## Determination 2007/73

### Refusal by a territorial authority to accept a window installation detail at Parehua Country Estate, Martinborough

Figure 1: Elevations of the 114m<sup>2</sup> dwelling

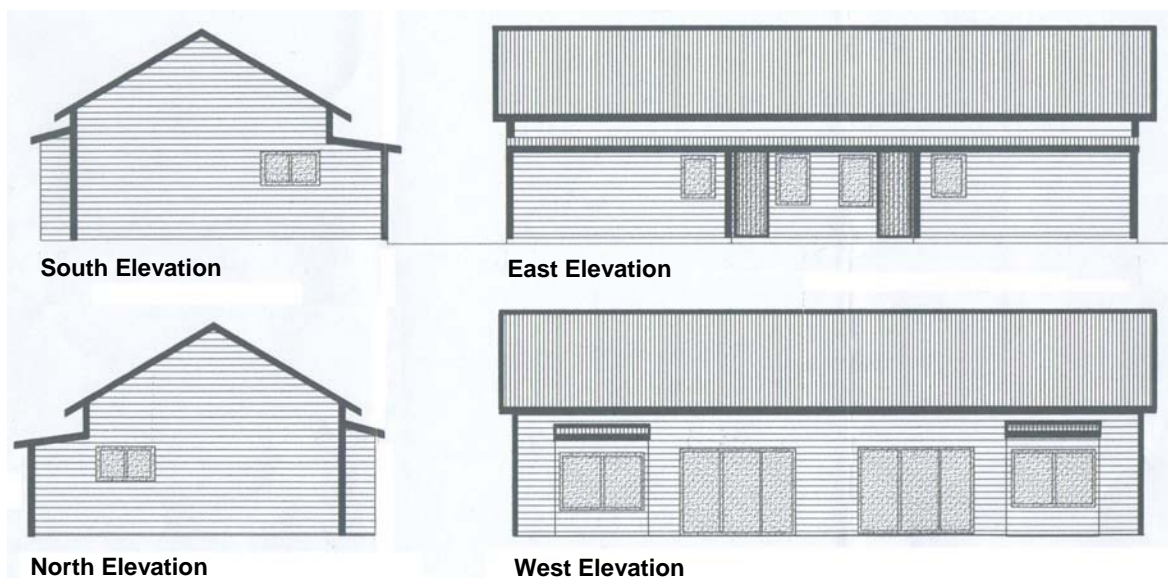
- 4.1 These are low risk dwellings, as assessed using the E2/AS1 Risk Matrix, but they are in a high to very high wind zone. No drawings were supplied with the application, but at my request, the applicant subsequently submitted some unscaled drawings showing a section through the 114 square metre dwelling and four elevations. The drawings appeared to show that the windows in the side (long) walls are protected by the eaves but the windows in the two gable ends, with up to 12 board widths distance up to the eaves, receive much less protection and are therefore at a greater risk of moisture entry resulting from a combination of wind and rain.

- 4.3 The flashing detail installed by the applicant is not fitted back against the framing and under the building wrap. In the event of moisture ingress any water will find its way into the building framing. This detail could only be considered adequate where the top of the windows are located close to protective eaves.

- a) the head flashing detail, as installed in the gable ends of the dwellings (typified by the South and North elevations of the 114 square metre house shown in Figure 1) does not comply with the Building Code.
- b) the head flashing detail, as installed above windows in the side walls of the dwellings (typified by the East and West elevations of the 114 square metre house shown in Figure 1) does comply with the Building Code.
- c) the head flashing detail as installed over the ranch-slider doors (typified by the West elevation of the 114 square metre house shown in Figure 1) does not comply with the Building Code.
